**DEFENSE NUCLEAR FACILITIES
SAFETY BOARD**

May 15, 2024

Final Design of the Continuous Air Monitor (CAM) System for the Safety Significant Confinement Ventilation System (SSCVS) at the Waste Isolation Pilot Plant (WIPP)

Figure 1. Representative CAM Design (adapted from [11])

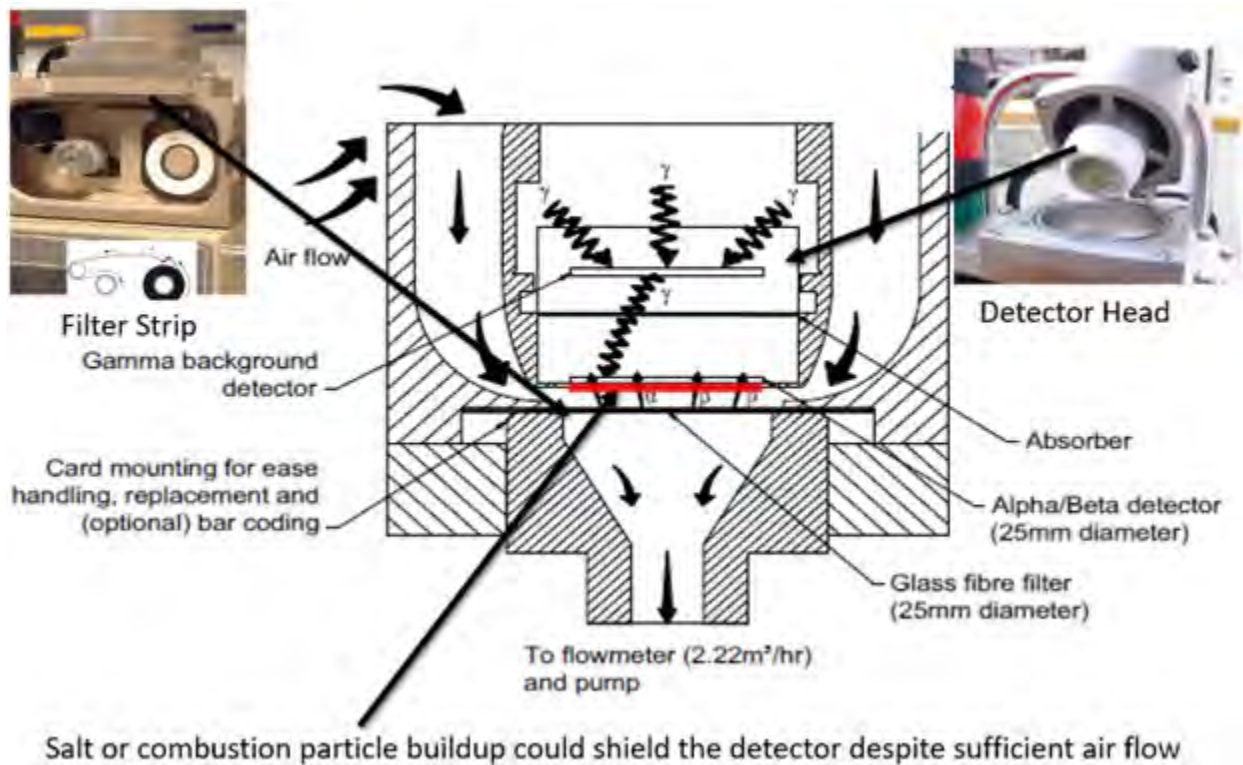
CAMs in the WIPP mine are subject to inflow of airborne salt particles. The CAMs are also required to perform their safety functions while being subject to a smoke-filled environment resulting from a postulated accident event that the safety instrumented system is designed to mitigate. Despite sufficient air flow, airborne particles of salt and combustion products may build up on the detector, shielding alpha and beta radiation from reaching the detector (Figure 1). This could affect the detector's performance before the accumulated particulate obstructs the airflow through the CAM sufficiently to trigger a protective action from the safety instrumented system to align SSCVS into a safe configuration to avoid a radiological release to the surface. This would impact the ability of SSCVS to perform its safety function. The magnitude of this shielding effect has not been evaluated or quantified. Even though the design uses a CAM array consisting of three separate CAMs, any of which can initiate the safety function, they are all subject to the same environment, which can serve as a potential common mode failure initiator.

SIMCO has maintained that the operating environment is not considered as part of the SIL analysis. This amounts to an assertion that the operating environment has no effect on component reliability. However, the environment in which the safety significant CAMs operate

could have a significant impact on their performance, as recognized in ANSI/ISA-84.00.01-2004.

The CAMs are the most robust version available from the manufacturer and have been fitted with titanium-clad detectors to better withstand the salt dust environment. But this does not mitigate the potential alpha and beta particulate shielding effects from particle buildup. The effects of the environment in which the CAMs operate should be further evaluated to ensure it will not affect performance of the CAMs' safety function. Ideally, this evaluation should be supported by test data.

Figure 2. Illustration of Underground Airflow

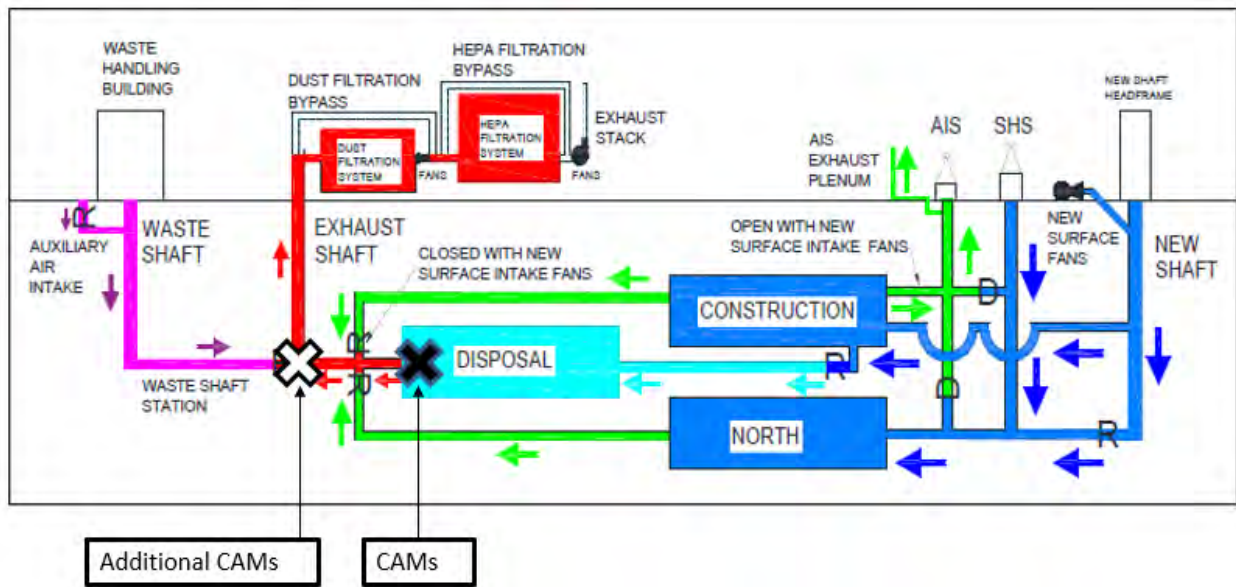
SSCVS is not used as a Safety Control to Mitigate Accidents at the Underground Waste Station—Transuranic waste is present at three main areas in the underground: (1) the waste shaft station during waste download; (2) the transport path while waste is being moved from the waste shaft station to the waste panel; and (3) the active waste (disposal) panel where the waste is permanently emplaced (Figure 2). Accident events with high consequences to the collocated worker have been identified in these three areas [1]. CAMs are located at the disposal panel. Additional CAMs could be located at the waste shaft station.

SIMCO will credit the initial condition [12], the administrative controls, and the engineered control to reduce the risk of postulated events along the transport path and at the waste panel. However, SIMCO only credits the initial condition and administrative controls for the waste shaft station (Table 1). DOE Standard 3009-2014 [2] establishes that due to the inherent uncertainty of human performance, engineered controls are preferred over administrative controls.

Crediting SSCVS/CAMs as an engineered control for accidents at the waste shaft station would require locating CAMs at the waste shaft station near bulkhead 308. It would also require a damper actuator capable of isolating the salt reduction system in 30 seconds or less [4] [13]. SIMCO confirmed that the damper’s actuator will be capable of isolating the salt reduction system in as little as five seconds [14].

Based on DOE’s preferred hierarchy of controls and the capability of the CAM system to perform this safety function at the waste shaft station, the omission of SSCVS/CAMs as a credited control for these potential accidents is inconsistent with DOE Standard 3009-2014.
